ADDENDUM #2 for **BID – Annex UPS Replacement** (4/25/2024)

PARTIAL LEVEL 100 PLAN

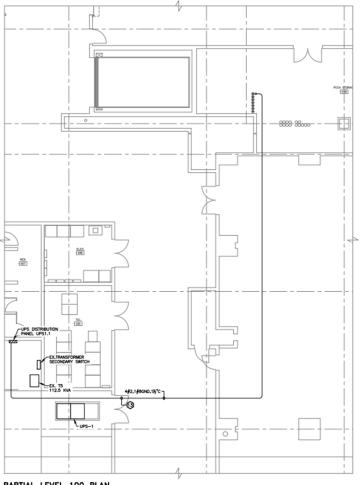
1) Where is the location for the new IDF panel? It is not shown on the drawings. Answer: The new IDF panel is located on the second level (one level above UPS room). See diagram below. The wiring to this panel and the panel itself will be furnished and installed on another project/bid. You do not need to include the cost for that cable run or panel on this UPS Replacement bid.
